# VENDOR SERVICE PUBLICATION

**SUBJECT:** Bendix Service Bulletin No. 629

Inspection and replacement of certain Bendix Aircraft Magneto Brown Distributor Blocks as used on turbocharged six (6) cylinder engines.

Figure 1  
D-2000/D-3000 Series  
Batch Codes 0000 through 8552

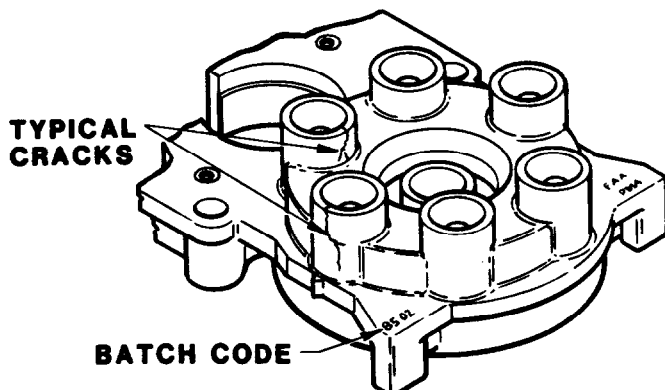
To remove from service distributor blocks that may contain outlet tower cracks. See Figures 1 through 3.

Field reports indicate some brown distributor block towers may crack (ref. Figures 1 through 3). Should the tower or towers crack the indications could be loss of ignition to the associated spark plug(s) or possible misfiring and/or cross firing of the engine.

1. Following published procedures, remove the harness cover or adapter plate from the Magneto. Using a high intensity light, inspect each distributor block tower for open cracks as shown in Figures 1 through 3.

All affected equipment must be inspected in accordance with this bulletin within the next 25 hours of operation and at regularly scheduled maintenance events not to exceed 100 hour intervals thereafter until suspect blocks are replaced with those having batch codes not listed as affected.

CAUTION: BEFORE FURTHER FLIGHT, BLOCKS FOUND WITH CRACKS MUST BE REPLACED BY BLOCKS WITH BATCH CODES NOT LISTED AS AFFECTED UNDER THE "EQUIPMENT AFFECTED" SECTION OF THIS BULLETIN. FOLLOW PUBLISHED PROCEDURES.
